SUBJECT: **Safety Recall 22S02 – Supplement #1**

Certain 2014 - 2015 Model Year, Fusion and MKZ and 2015 Model Year Mustang Vehicles

Brake Stop Lamps Remain On

New! REASON FOR THIS SUPPLEMENT

FIGURE 3

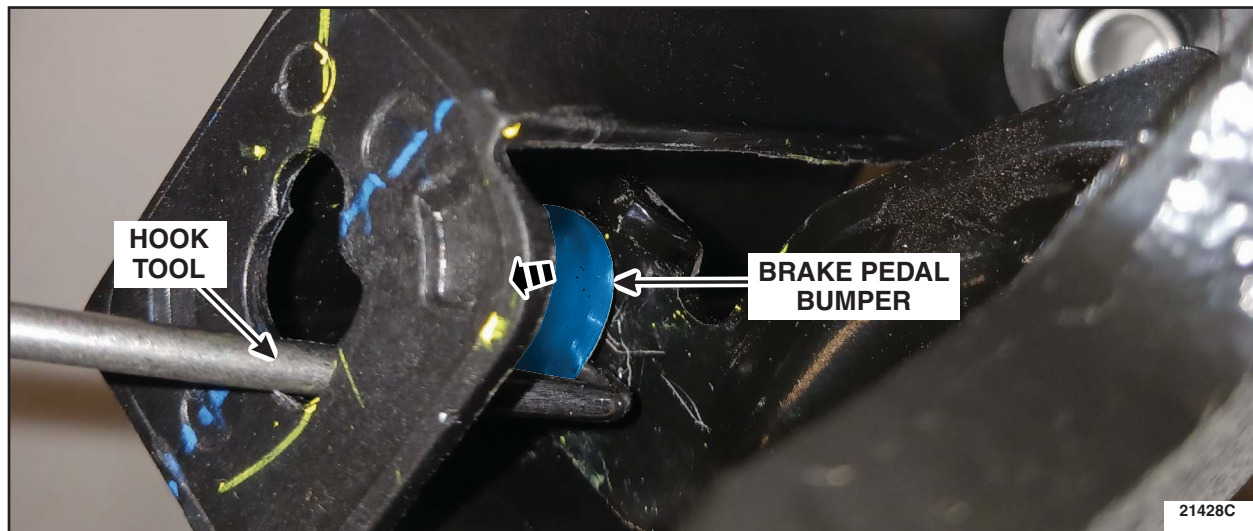
1. Remove the stoplamp switch. Please follow the Workshop Manual (WSM) procedures in Section 417-01.
2. Insert a hook tool through the stoplamp switch opening and remove the brake pedal bumper. See Figure 3.

FIGURE 4

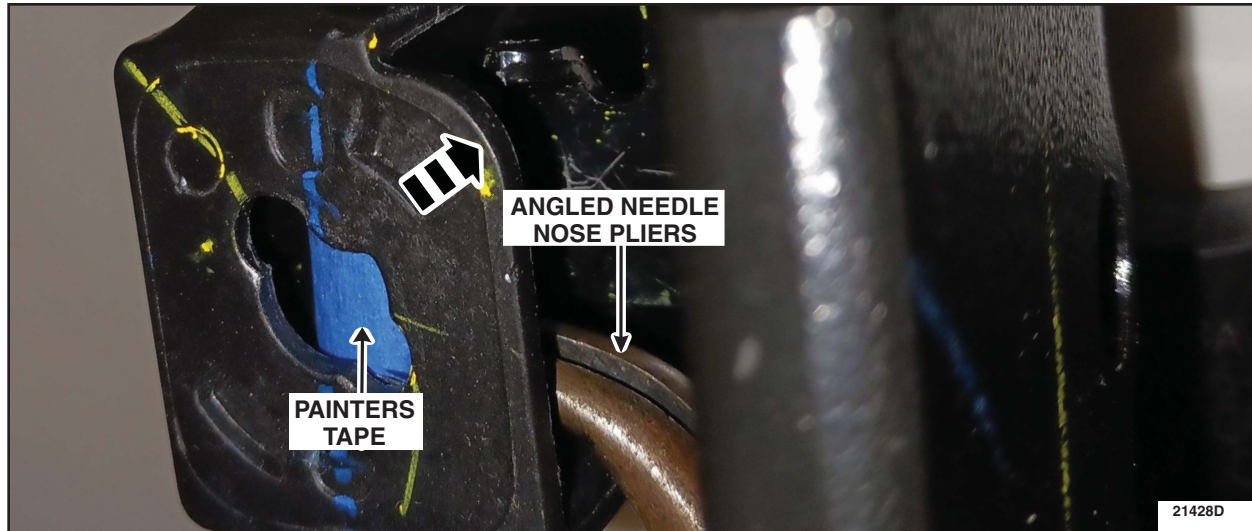
3. Apply a small piece of folded over painters tape to the **new** brake pedal bumper, and using angled needle nose pliers position the new brake pedal bumper for installation. See Figure 4.

FIGURE 5

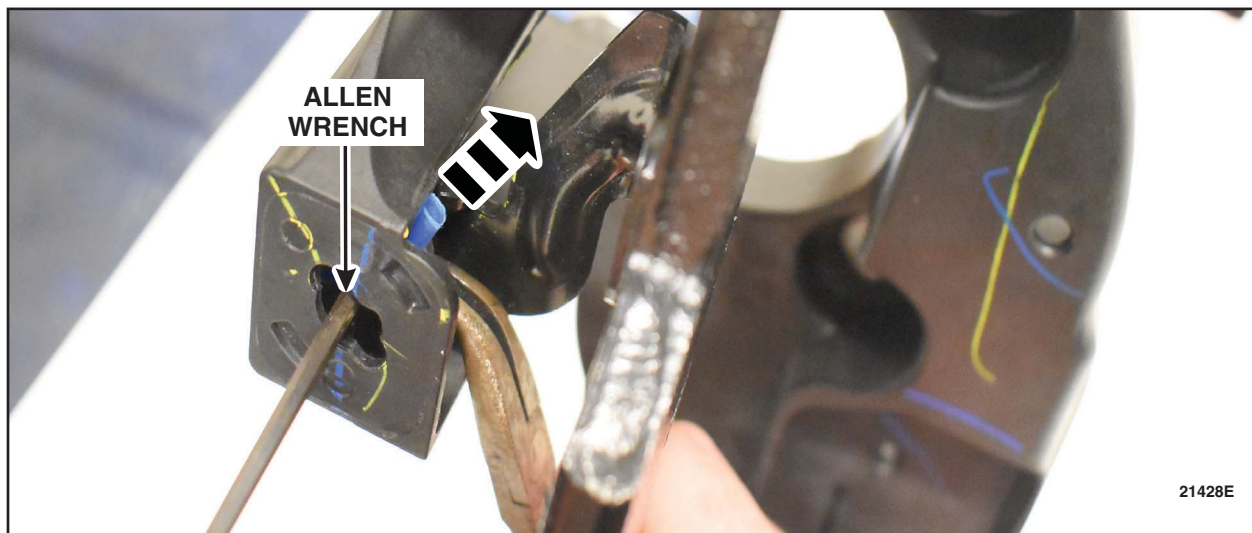
4. Insert a small allen wrench through the stoplamp switch opening and push the **new** brake pedal bumper into place. See Figure 5.

FIGURE 6

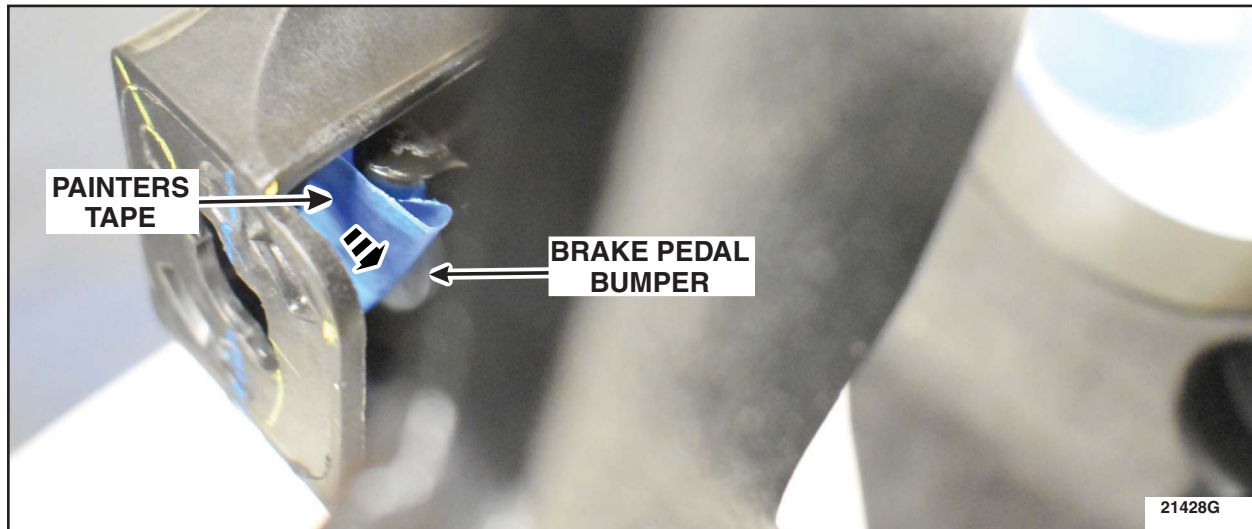
5. Remove the painters tape from the **new** brake pedal bumper. See Figure 6.

FIGURE 7

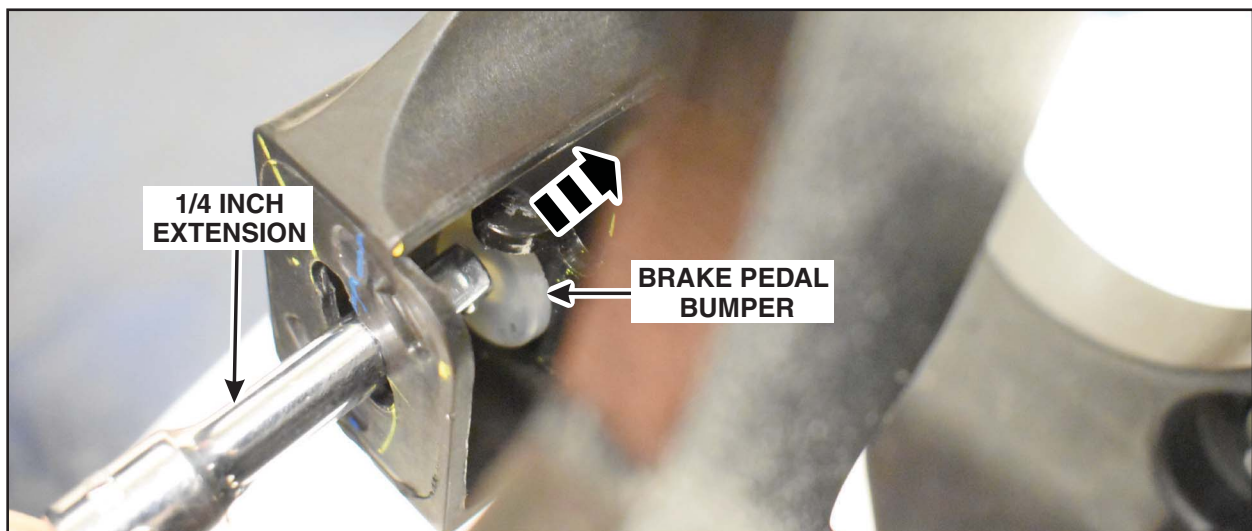
6. Insert a 1/4 in. extension through the stoplamp switch opening and push on the **new** brake pedal bumper ensuring that it is fully seated into place. See Figure 7.
